SHELLY'S ROOST SUBDIVISION

APPLICATION NUMBER 13 DATE April 4, 2013

REQUEST Subdivision

DETAIL SITE PLAN

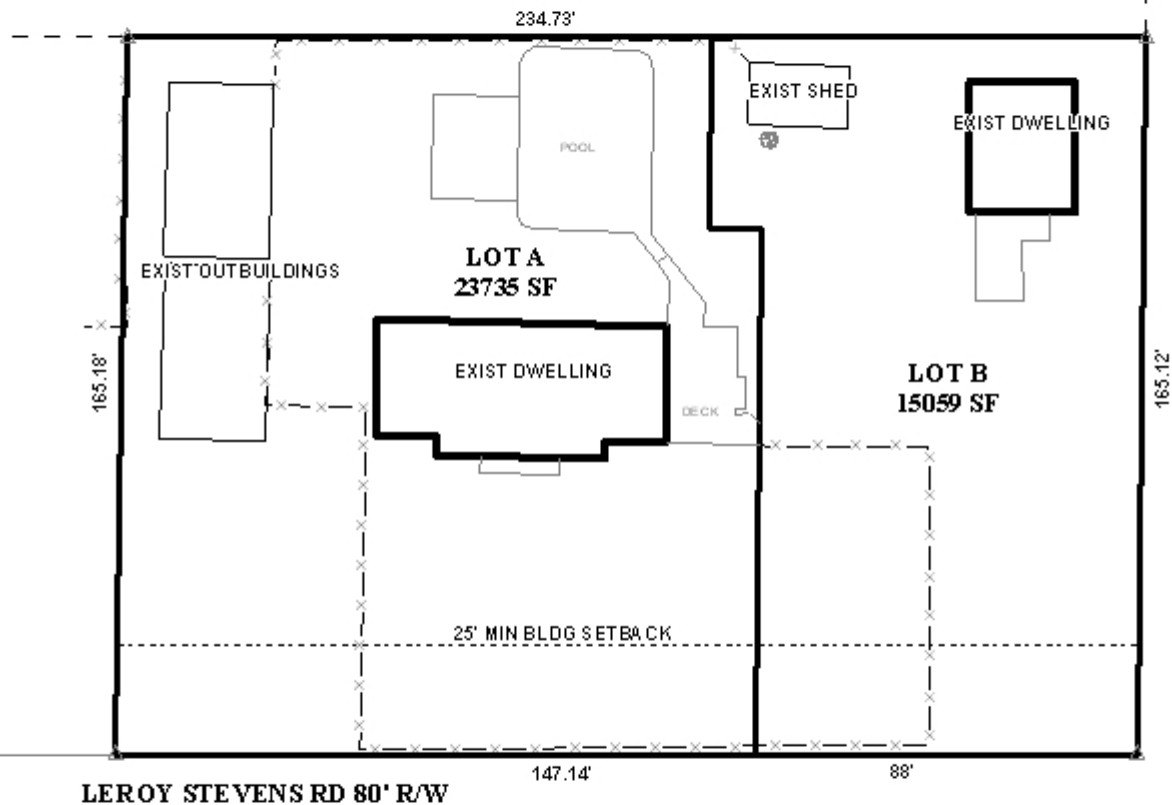
The site fronts onto Leroy Stevens Road, a paved street with a compliant 80' right-of-way; therefore, no dedication would be required. As a means of access management, a note should be placed on the Final Plat limiting each lot to one curb cut to Leroy Stevens Road, with the size, design, and location of the curb cuts to be approved by Mobile County Engineering and conform to AASHTO standards.

As on the preliminary plat, the 25' building setback line should be illustrated along Leroy Stevens Road. Each lot should be labeled with its size in square feet and acres, or a table should be furnished on the Final Plat providing the same information.

- 1) placement of a note on the Final Plat stating that each lot is limited to one curb cut to Leroy Stevens Road, with the size, design, and location of the curb cuts to be approved by Mobile County Engineering and conform to AASHTO standards;

- 2) illustration of the 25' minimum building setback line along Leroy Stevens Road;
- 3) labeling of each lot with its size in square feet and acres, or the furnishing of a table on the Final Plat providing the same information;
